Re: MMC Staff Parking Garage | 222 St. John Street | Level III Site Plan
Response to D Street & St. John Street Intersection Comments

Comment letter from TYLIN International Traffic Dated February 26, 2019

Comment letter from City of Portland Public Works Dated February 19, 2019

1. Revisions to St. John & D Street Intersection Sketch

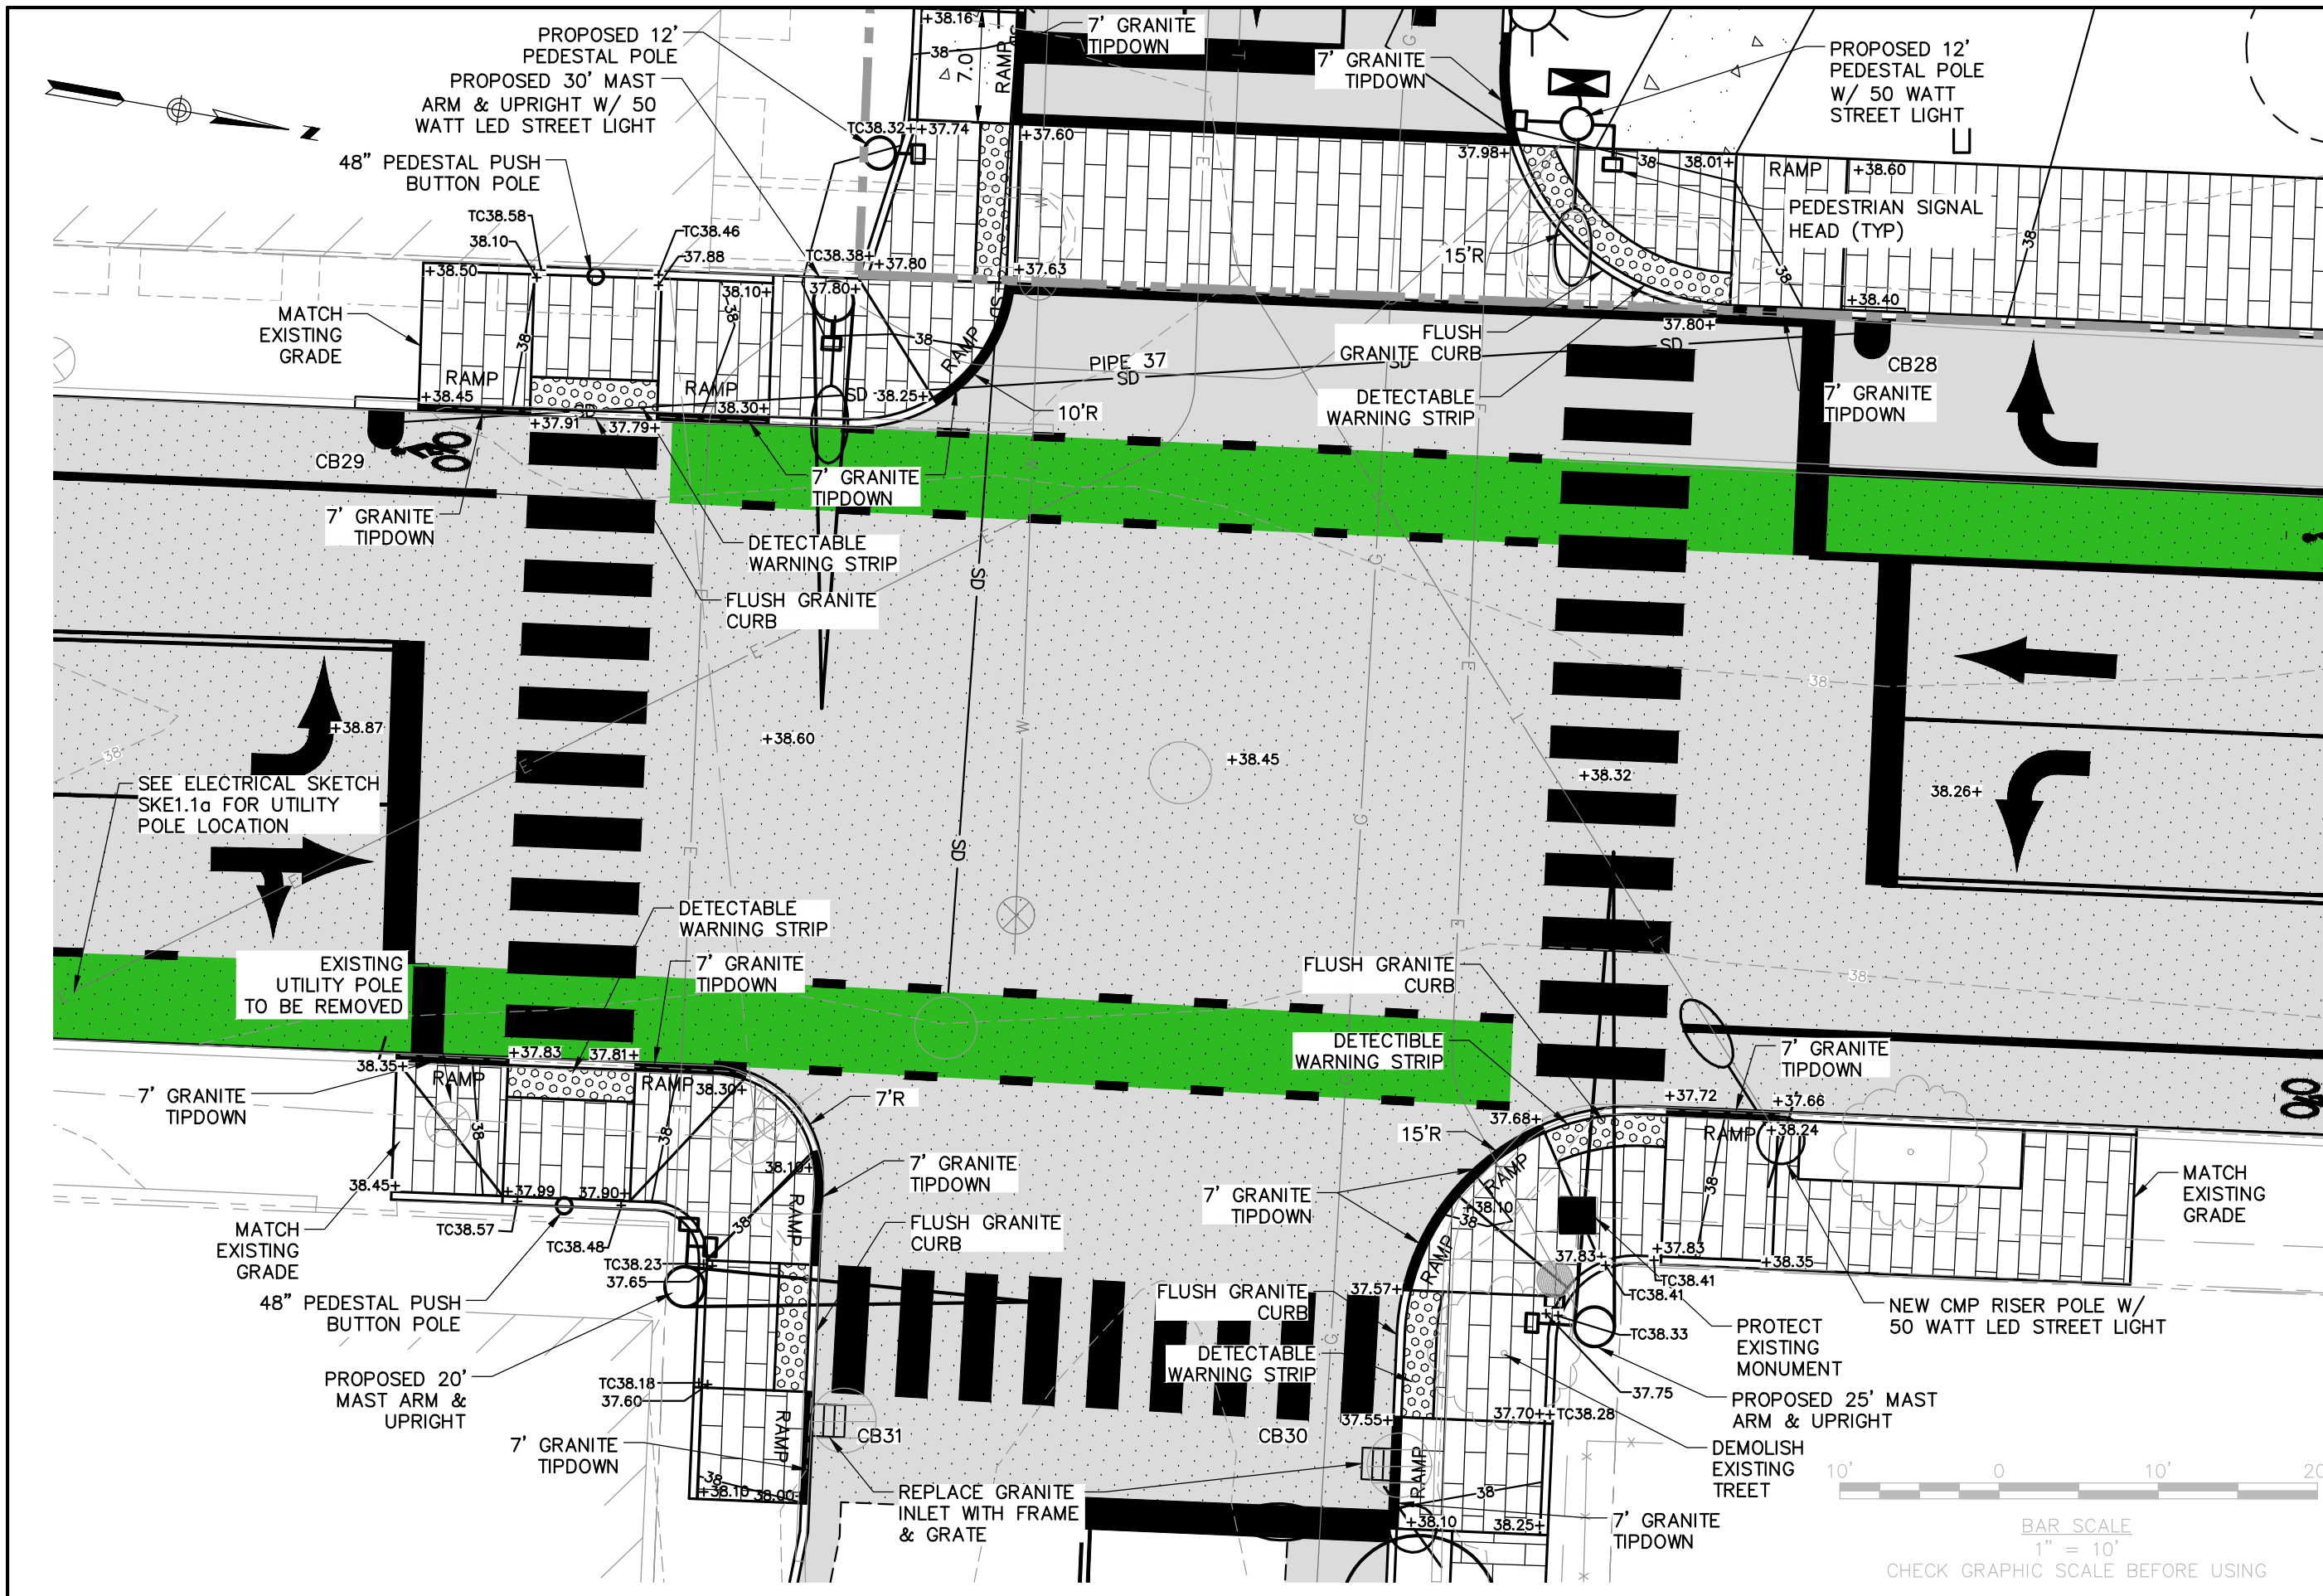
1. *The mast arm located on the southeast corner is labeled as a "Proposed 12' Pedestal Pole". This shall be corrected*

2. *I do not support the location of the utility pole in the flare of the sidewalk ramp located on the southeast corner.*

3. *Although the MUTCD does not specifically note standards for cone of vision for pedestrian signal heads, it is suggested that they be located as close as practicable to a pedestrian looking directly in line with the crosswalk.*

5. *The mast arm on the northwest corner should be depicted.*

6. *A pedestrian signal head for crossing St. John Street should be depicted on the northeast corner mast arm.*

7. *The Applicant should document that the push buttons meet MUTCD requirements for accessibility and separation.*

1. *We are happy to see the new separated ramps in place of the apex (diagonal) ramps. However, in the ramps on the northeast and southeast corners of the intersection, there appear to be ramp sections that are not perpendicular to the path of travel (i.e. apron ramps), so that someone who is ramping up or down would be doing so with an undesirable cross slope. I realize that these may have been the only way to get separated ramps given our requirements for 7" curb reveal; however, I believe it may be possible construct perpendicular ramps if the curb reveals was reduced to 6" (or 5" minimum) in the vicinity of the ramps. If the application could assess whether perpendicular ramps could be installed given a reduced curb reveal, that would be preferred over the current layout.*

Similar changes could be made to the southwest corner of the intersection, but these are less necessary because this corner does not feature slanted ramps.

These changes to ramp design may reduce the footprint of the ramp and make it easier to place signal equipment.

Response: Please see the attached revised Sketch. The label has been updated to reflect a 48" Pedestal Push Button Pole.

Response: This pole has been removed, new electrical in this location will not be supplied from an existing pole located near the intersection, there will be no new poles at the southeast corner.

Response. According to the MUTCD, the push button (and presumably the pedestrian head) should be located within 5 feet of the extension of the crosswalk. The proposed design has 7 pedestrian heads and 8 pushbuttons within the recommended area. The either pedestrian head location on the southwest corner of the intersection for pedestrians crossing St. John Street meets the criteria for a push button but is approximately 4-feet off from meeting the criteria for the pedestrian head. The reason for the off-set pedestrian head is due to the right of way located at the back of the sidewalk and the desire not to encroach into the sidewalk any more than necessary.

Response: There is no mast arm required or proposed for the northwest corner of the intersection. Signal heads for traffic exiting D Street will be located directly on top of the 12-foot pedestrian poles located on each side of the site access. Both locations fall within the cone of vision.

Response: Please see attached revised Sketch. Additional clarification has been provided for this pedestrian signal head.

Response: Due to the existing public right of way being very limited, not all the push buttons could be separated by the recommended 10 feet. According to MUTCD, "where there are physical constraints on a particular corner that make it impractical to provide the 10-foot separation between the two pedestrian pushbuttons, the pushbuttons may be placed closer together or on the same pole". There are MUTCD standards for push buttons that are not separated by 10 feet or on the same pole, which will be met.

Response: Please see the attached revised Sketch. Reduced curb reveal has been implemented to achieve the desired cross slopes.
